# Access Compliance Report

## Public Rights-of-Way

Intersection ID: 10021862	Main Street: BROADFORD_CT	Cross Street: N/A	Location: NE
ADA ID: 6671C2BA4773	Ramp Type: Perp	Initial Pass/Fail: Fail	Overall Compliance: No
			Severity Score: 50

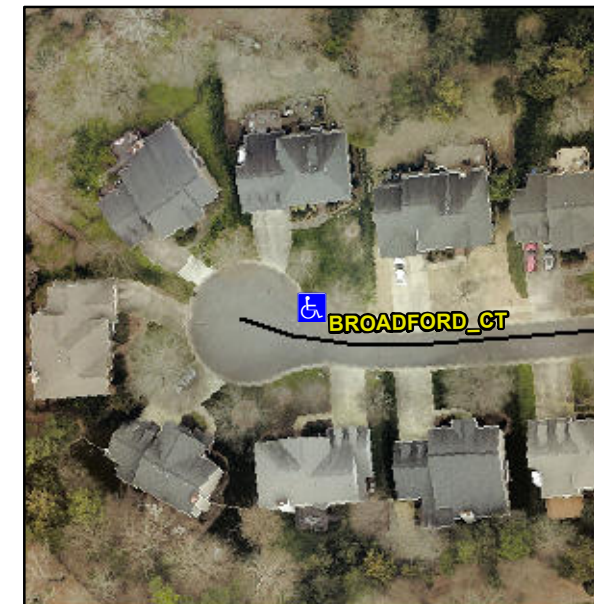
**R304.2.2, R304.5.3**

Compliance	Description	Data	Compliance	Description	Data
N/A	Ramp Length (in)	42.0	No	Ramp Slope (%)	14.9
Yes	Ramp Width (in)	48.0	No	Ramp XSlope (%)	9.0
N/A	Flare Type LT	N/A	N/A	Flare Type RT	N/A
N/A	Flare Slope LT (%)	N/A	N/A	Flare Slope RT (%)	N/A
N/A	Flare Traversable LT?	N/A	N/A	Flare Traversable RT?	N/A
N/A	Landing Length (in)	N/A	N/A	DWS Provided?	N/A
N/A	Landing Width (in)	N/A	N/A	DWS Contrast?	N/A
N/A	Landing Slope (%)	N/A	N/A	DWS Length (in)	N/A
N/A	Landing X Slope (%)	N/A	N/A	DWS Full Width?	N/A
N/A	Landing Curb? (Y/N)	N/A	N/A	DWS Offset (in)	N/A
N/A	Shared Landing?	N/A			
N/A	Gutter Ponding?	N/A	N/A	Gutter Slope (%)	N/A
N/A	Gutter Lip Ht (in)	N/A	N/A	Gutter X Slope (%)	N/A
N/A	Painted X Walk1?	No	N/A	Painted X Walk2?	N/A
	X Walk 1 Direction	To SW		X Walk 2 Direction	N/A
N/A	X Walk 1 Width (in)	N/A	N/A	X Walk 2 Width (in)	N/A
	X Walk 1 Slope (%)	0.4		X Walk 2 Slope (%)	N/A
	X Walk 1 X Slope (%)	2.9		X Walk 2 X Slope (%)	N/A

**Remove & Replace Entire Ramp.**
